17 December 2020

**SUBMISSION: SIRIUS STATE SSDA-10384
REGARDING 88 CUMBERLAND STREET, SYDNEY**

Figure 3 – Height exceedance above existing envelope (southern part of the site adjoining 88 Cumberland Street)

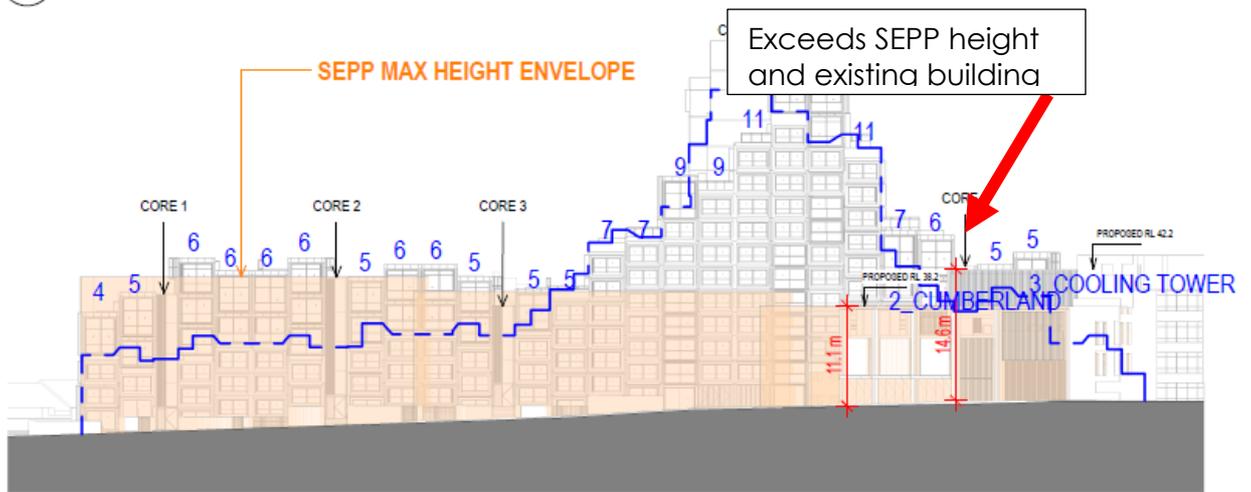
It is noted that the proposal exceeds both this site-specific control (RL38.2), as well as the existing Sirius envelope at the southern end of the site (refer **Figures 3** and **4** below). However, this is the point of the site where the potential for greatest impacts occur – i.e overshadowing.

- Shadow diagrams are requested by DPIE for the southern part of the site, showing a pool building complying with RL38.2 and the proposed apartments no greater than the existing Sirius envelope (in the southern part of the site). This will allow us to better compare if a "compliant scheme" has a better overshadowing impact for our site than a non-compliant scheme. If a worse outcome occurs, we recommend a compliant scheme is pursued.

Figure 4 – Height exceedance from SEPP for new pool building

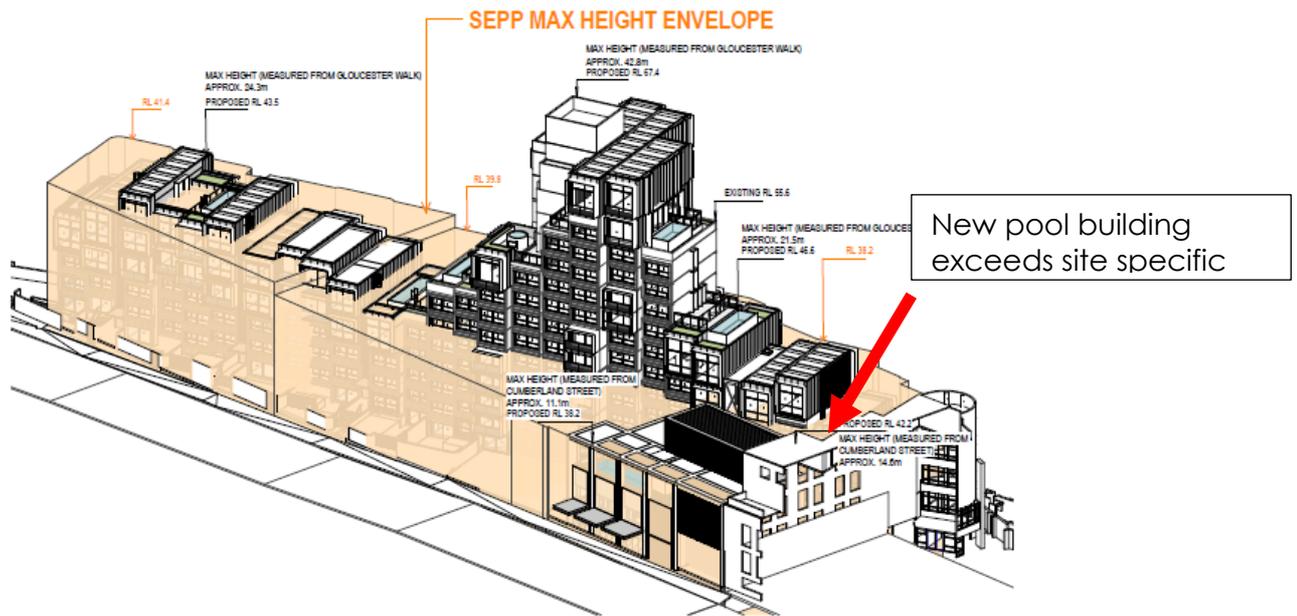
- We request that DPIE consider whether the height exceedances in this portion of the site affects the integrity of the assessment of the original SSP height limits with respect to view corridors and the Opera House. Given that the controls were drafted to be very site specific, variations to those controls may not be justifiable.
